Service Bulletin

Subject: McDonald's New Preheat Gap Setting
To: Factory Authorized Service Agencies US & Canada
Product: Garland Clamshell Models ME & MG
Date: April 05, 2018

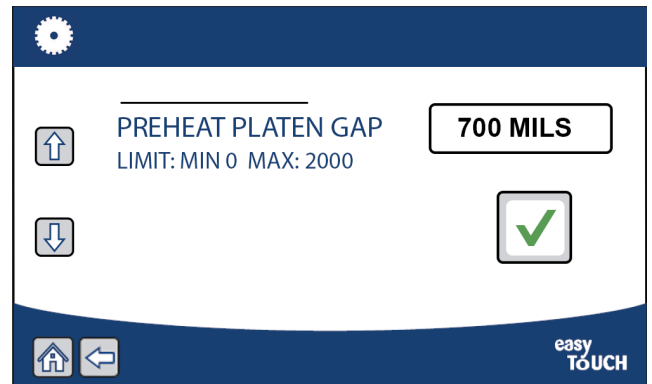
There have been reports of the upper platen coming down for preheating from AM to PM with the utensils (egg ring set) on the grill causing damage to the platen arm. In order to prevent this from happening the preheating gap between the grill plate and the platen will be increased.

GARLAND is working on implementing this change in production. In the interim please make a note of the following changes to all Garland grill models as detailed below with the new setting of 700 MILS.

4. Press the side button (numeric key pad will appear).

5. Key in the new gap dimension of 700 MILS then press "✓" checkmark to enter or X to cancel.
